Monitoring Report
FINAL VERSION
Horne Creek Tributaries Mitigation Project
Monitoring Year 2
Calendar Year of Data Collection: 2021

NCDEQ DMS Project Identification # 100026
NCDEQ DMS Contract # 7181
Yadkin River Basin (Cataloging Unit 03040101)
USACE Action ID Number: SAW-2017-01510
NCDEQ DWR Project # 2017-1156
Surry County, NC
Contracted Under RFP # 16-006993
Data Collection Period: October 2021
Submission Date: December 2021

RE: WLS Responses to NCDEQ DMS Review Comments for Task 8 Submittal, Monitoring Year 2 Report for the Horne Creek Tributaries Mitigation Project, DMS Full-Delivery Project ID #100026, Contract #7181, Yadkin River Basin, Cataloging Unit 03040101, Surry County, NC

**FIGURE
1**

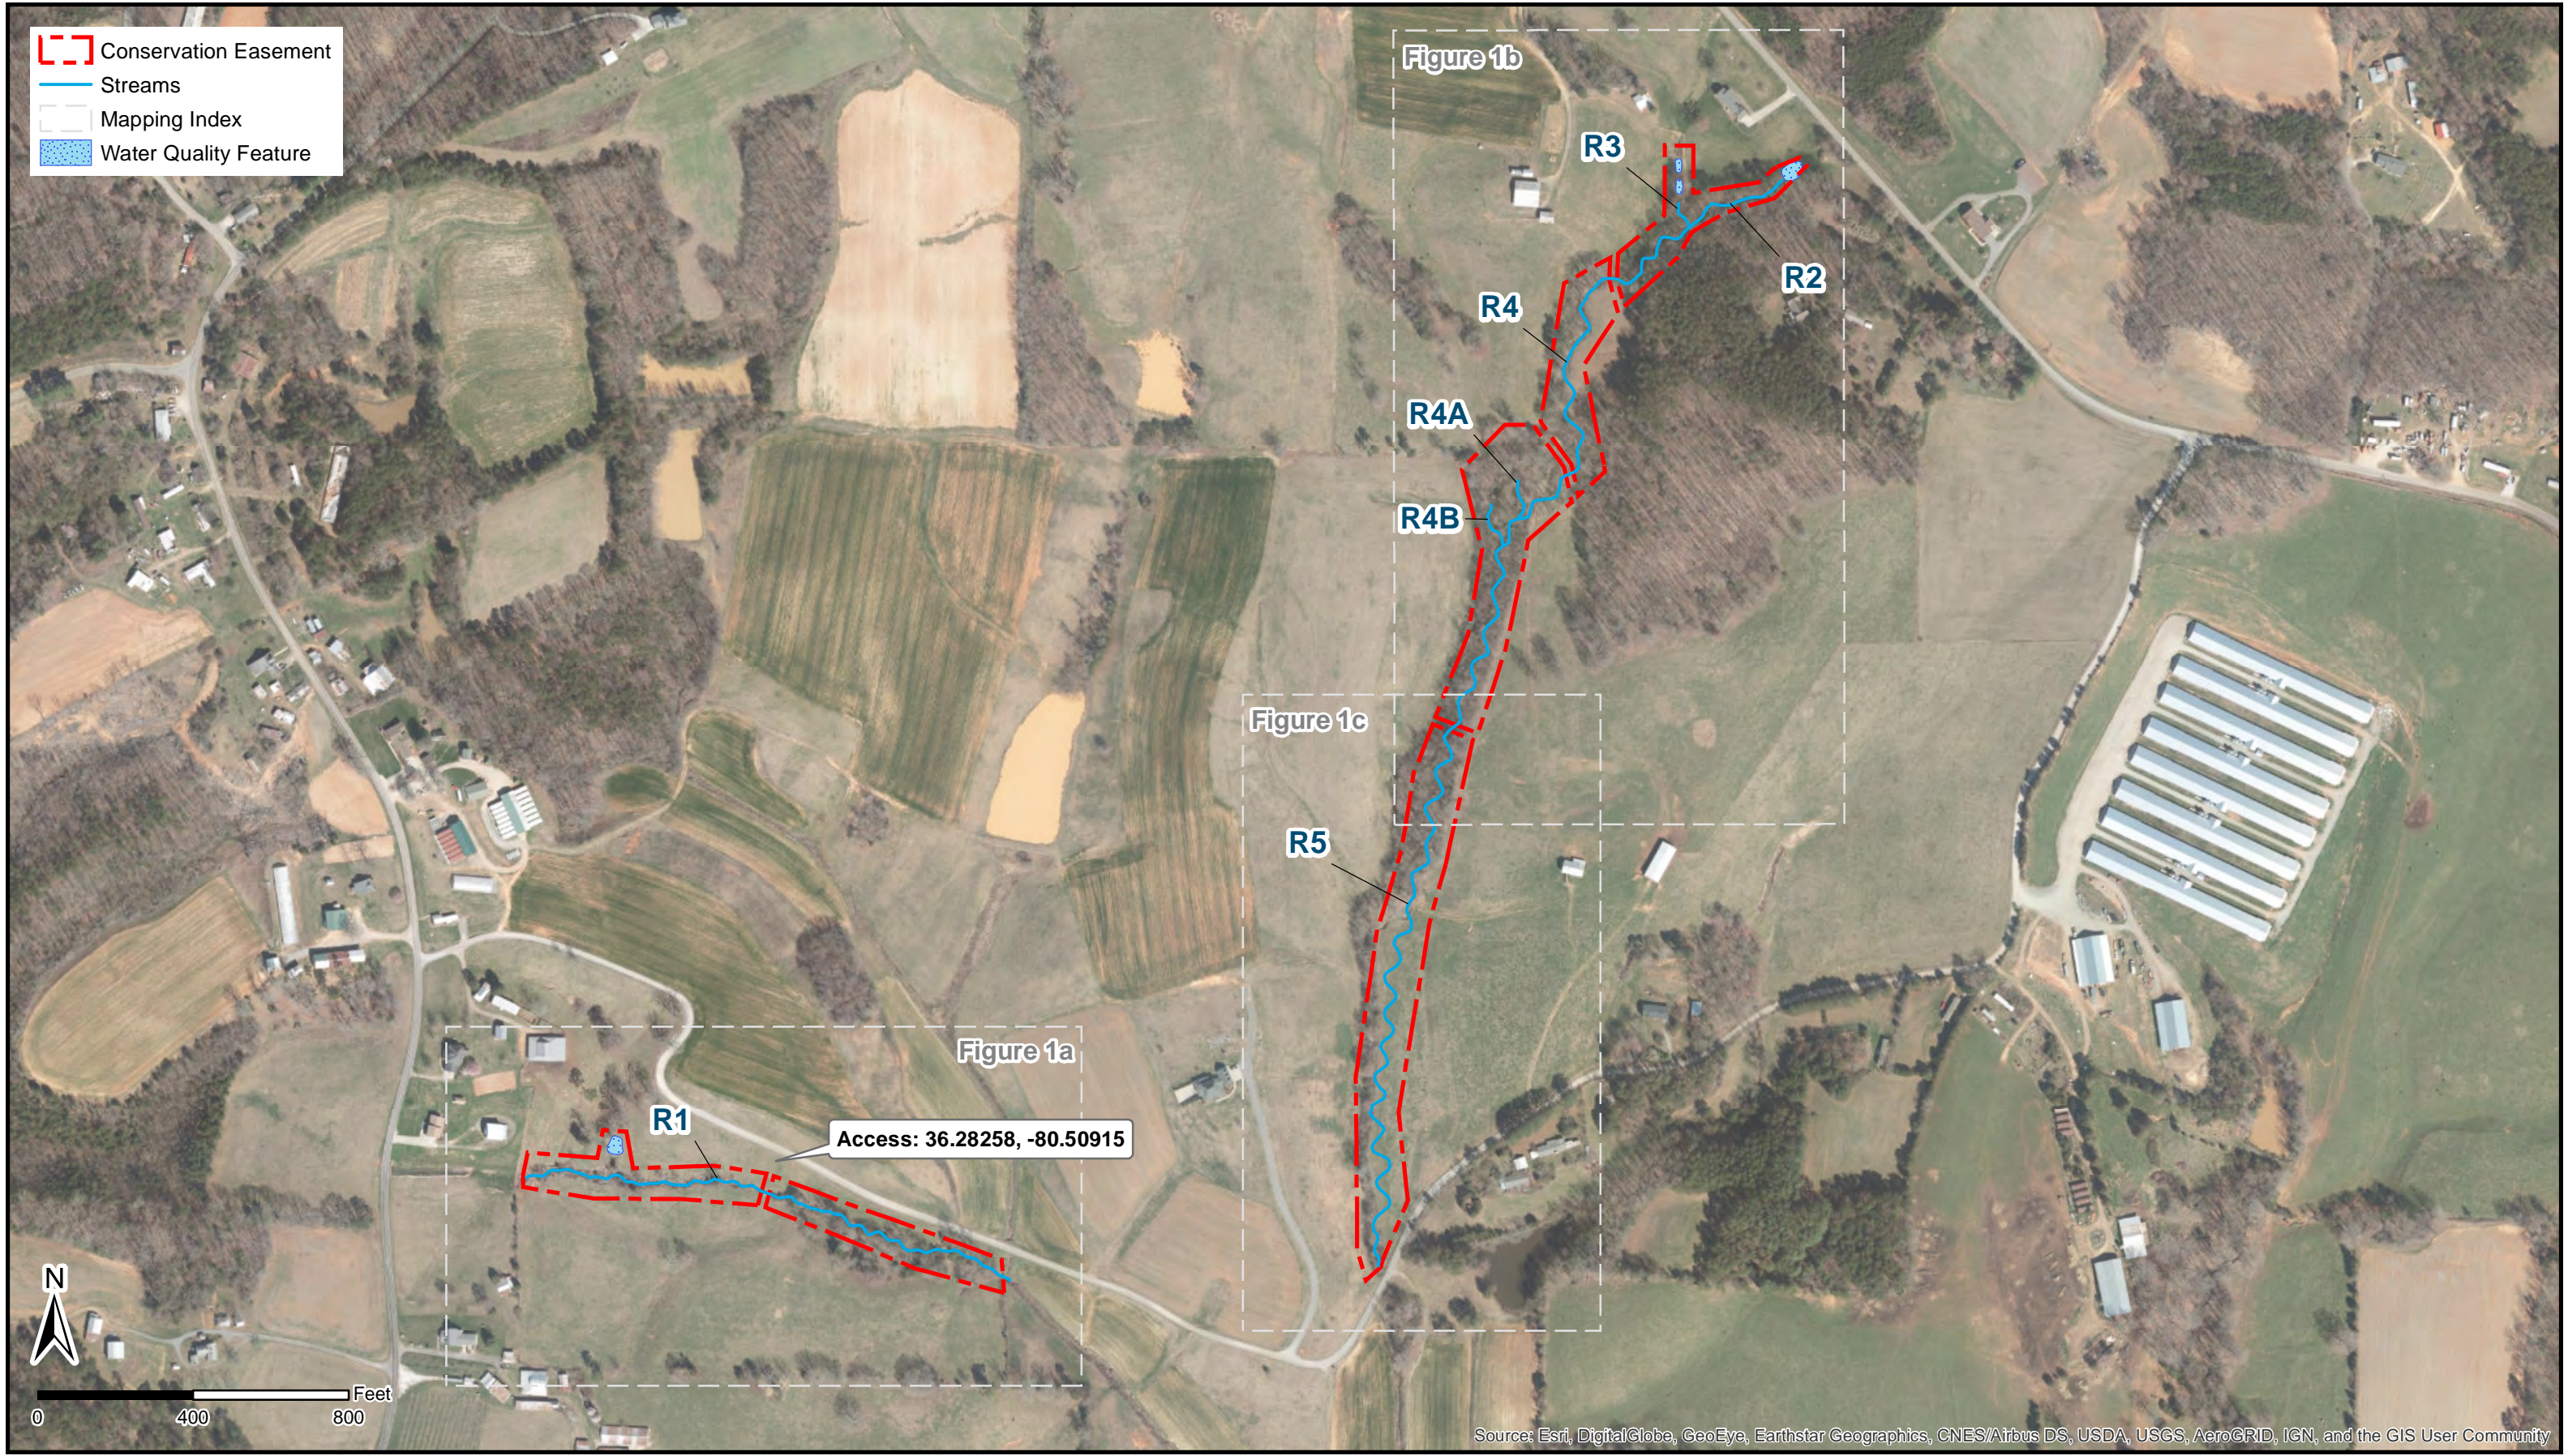
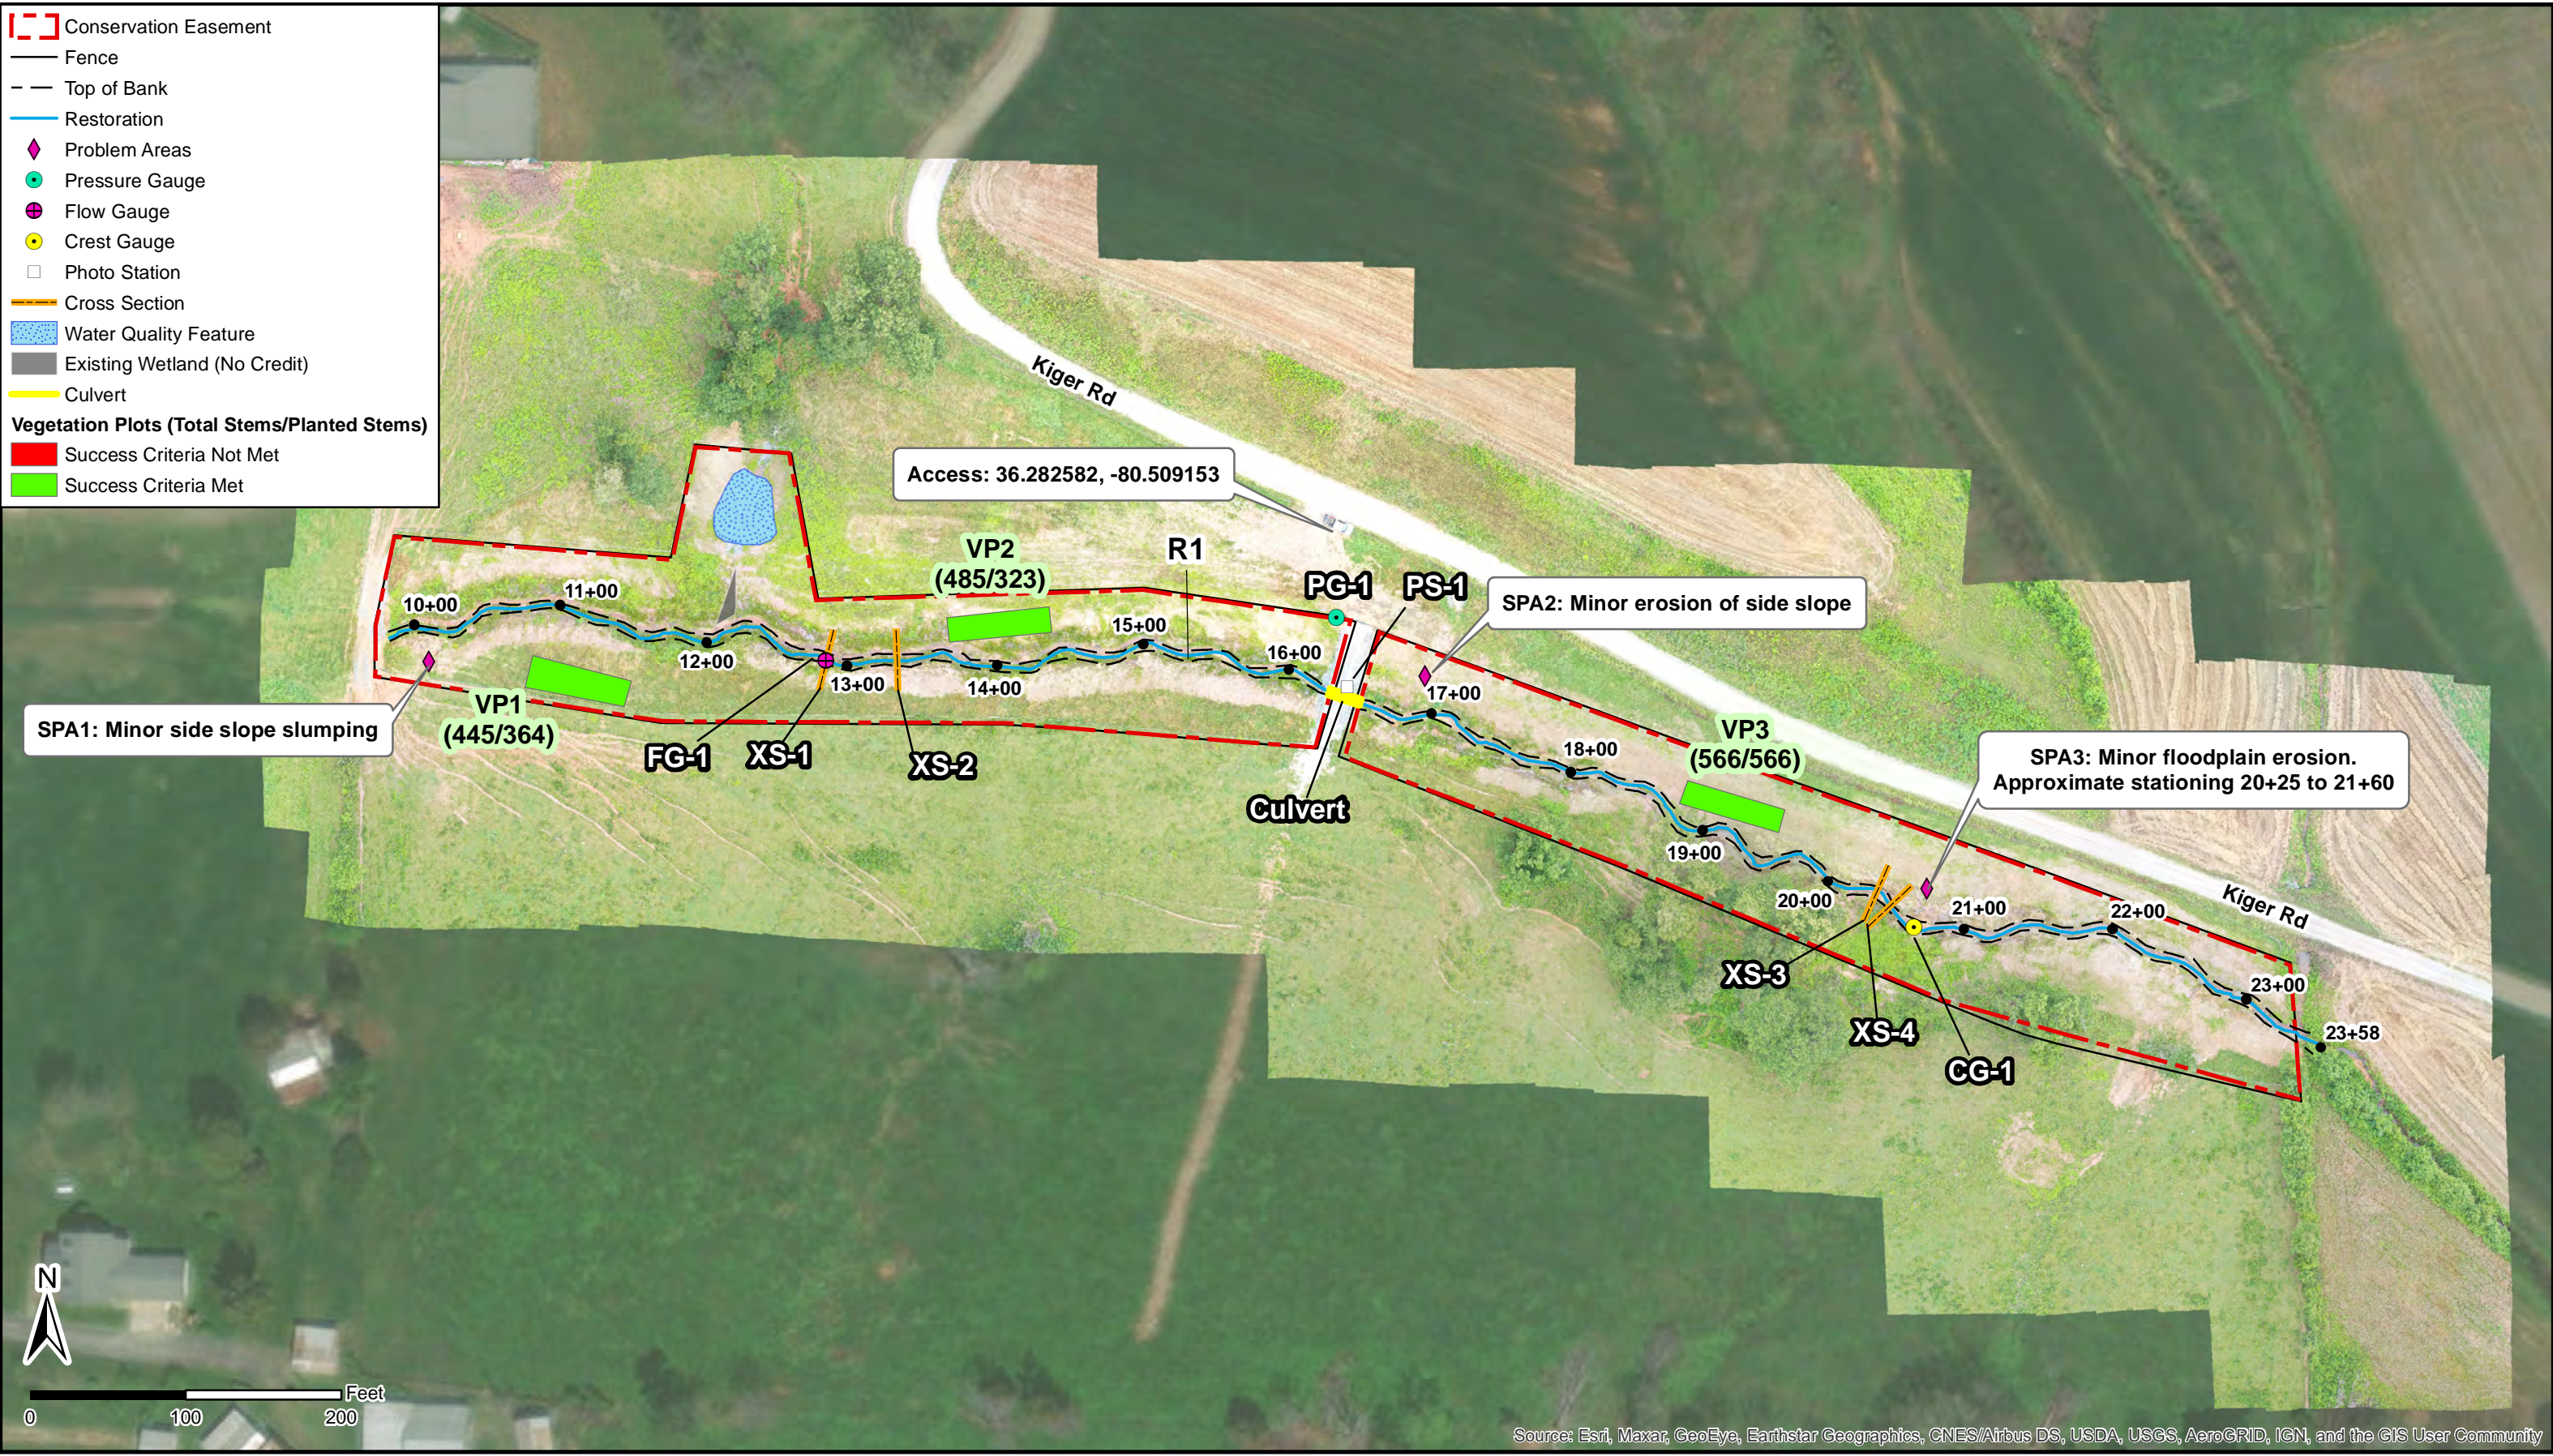
- **Table 2: Add “Livestake Planting/Maintenance – Feb 2021” to table.** Response: A row was added to capture this information.
- **CCPV: Consider adding reach breaks. It is difficult to know where R2, R4 and R5 transition between each other.** Response: Labels were added for reach breaks on the CCPV.

- **Table 5: There is one grade control structure listed as not performing as intended. Please use a call out or symbol for this structure on the CCPV.** Response: This area is called out on the CCPV as SPA8.
